STOREY PARK PARCEL J FINAL PLAT

SUMMARY

Major Subdivision for the final plat of Parcel J of the Wewahootee PD.

CONDITIONS OF APPROVAL

BOUNDARY SURVEY

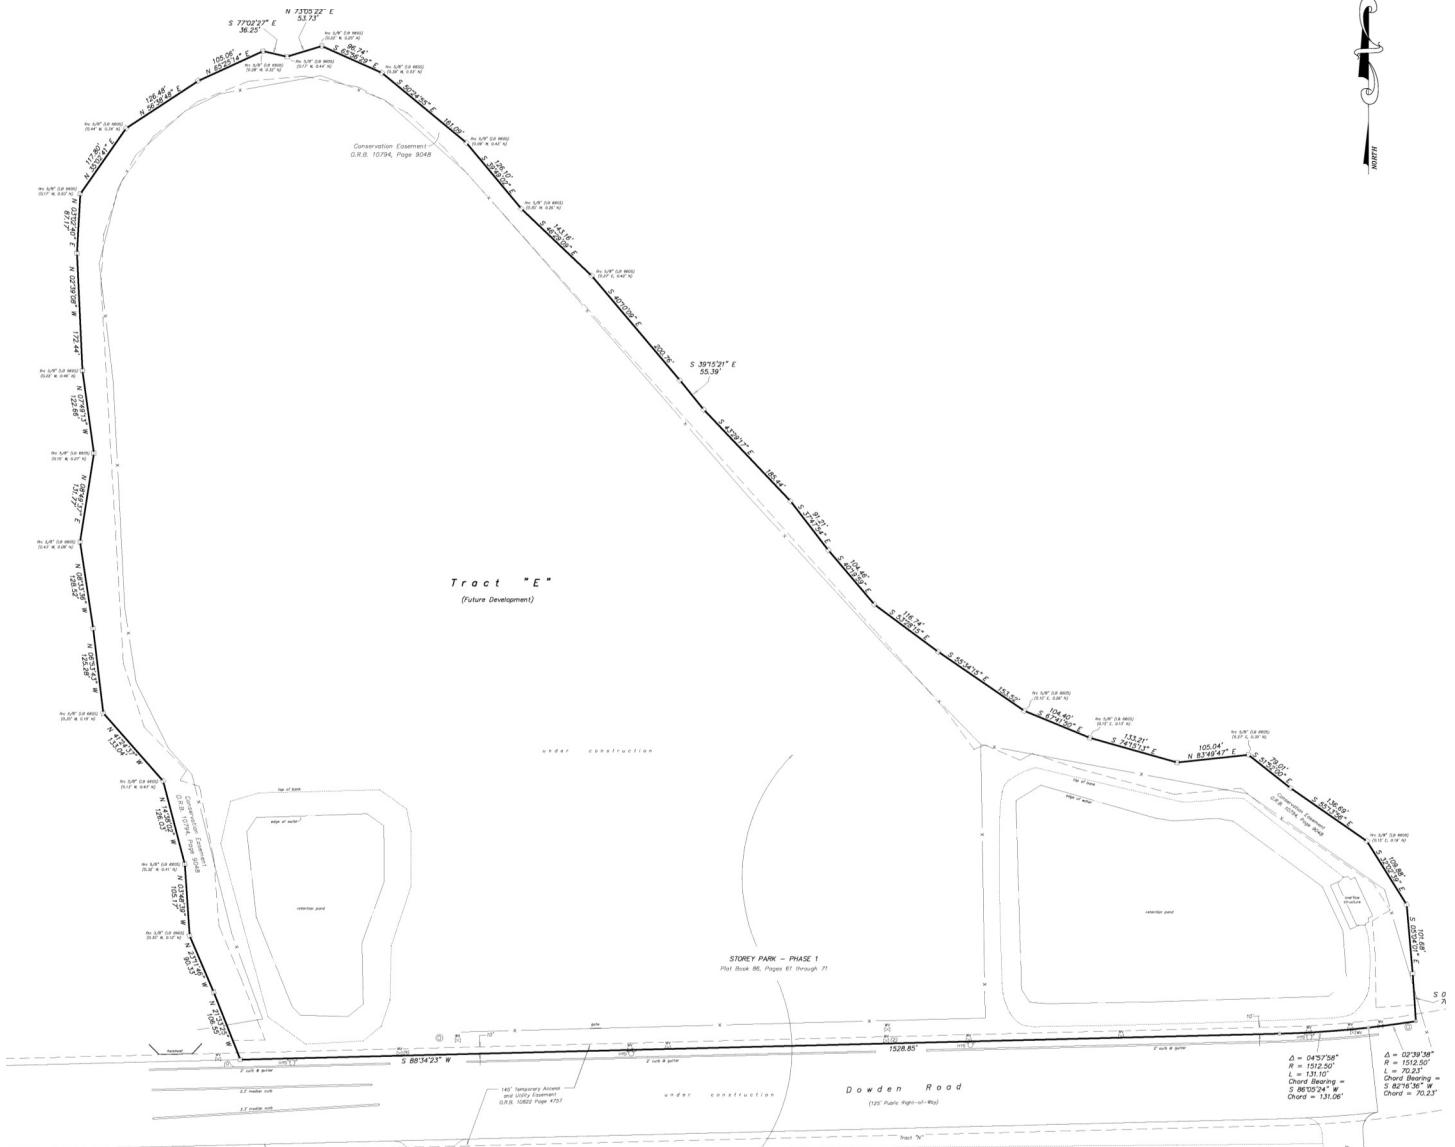
1. Sheet: (Boundary Survey) The 10' Multi-Purpose & Utility Easements aren't shown.
2. Sheet: (Boundary Survey & Plat) There's a dimensioned POL PRM missing on the south line of Tract E to meet the 1400' placement requirement.

PROPOSED PLAT

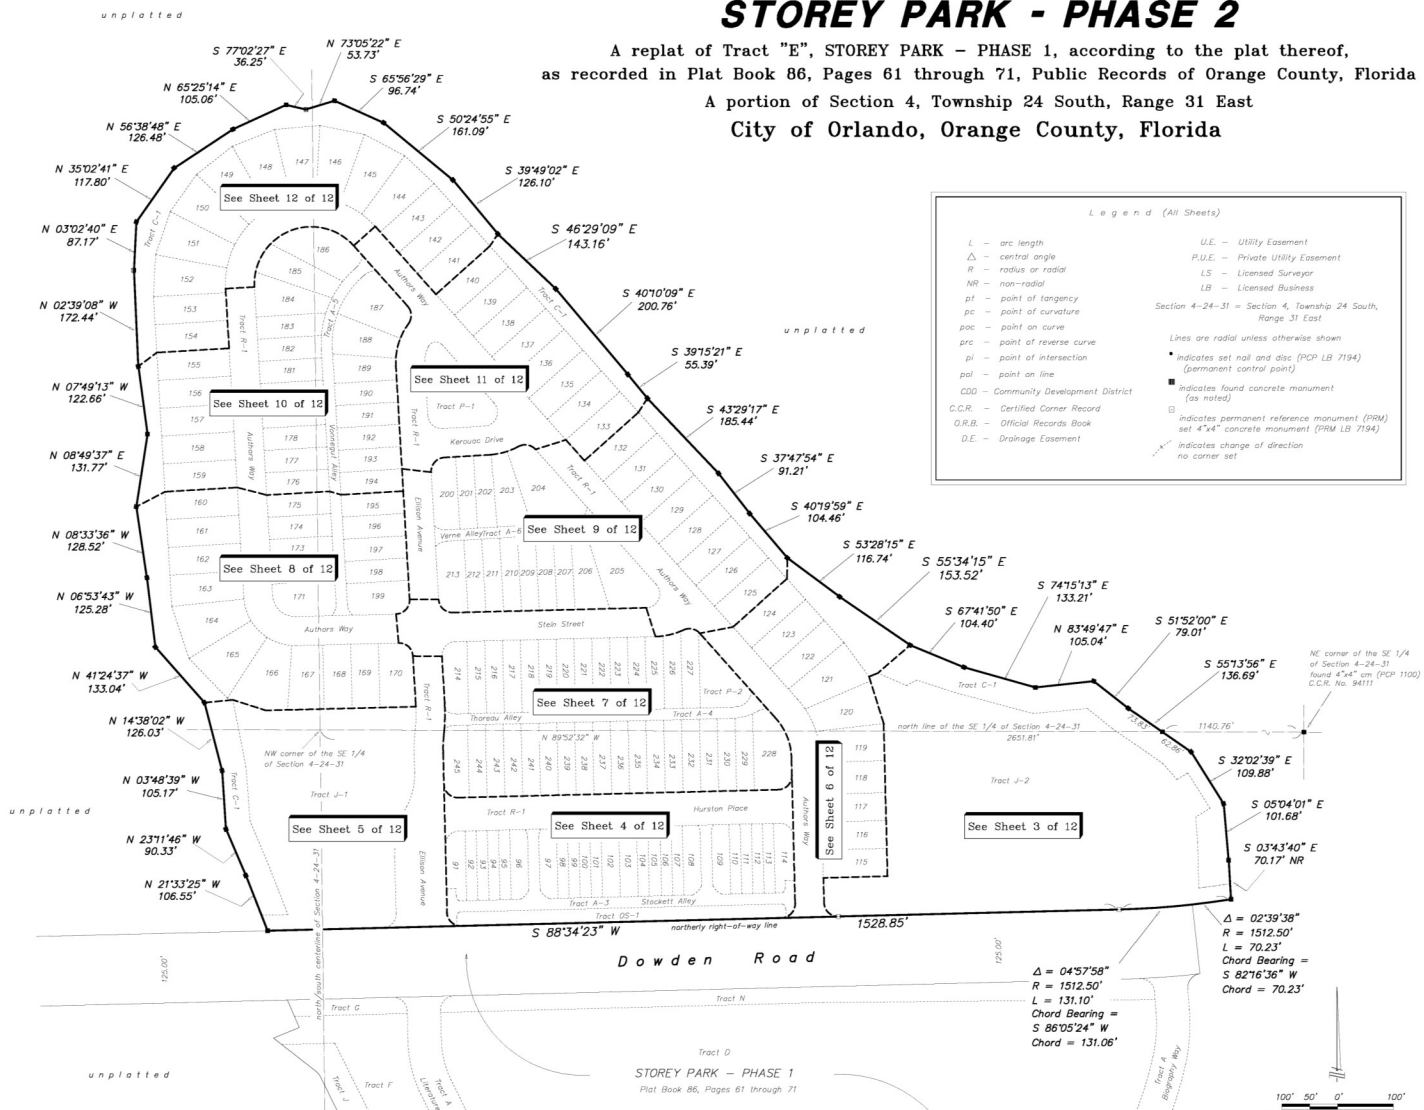
3. Sheet 1: (Plat) The 10' Multi-Purpose Easement being dedicated needs to be in the Dedication.
4. Sheet 7: (Plat) The Thoreau Alley width is missing.
5. Sheet 2: (Plat) The match line of sheet 2 of 12 needs to be changed at the PC and PT on west end of Hurston Place to reflect sheet 4 of 12.
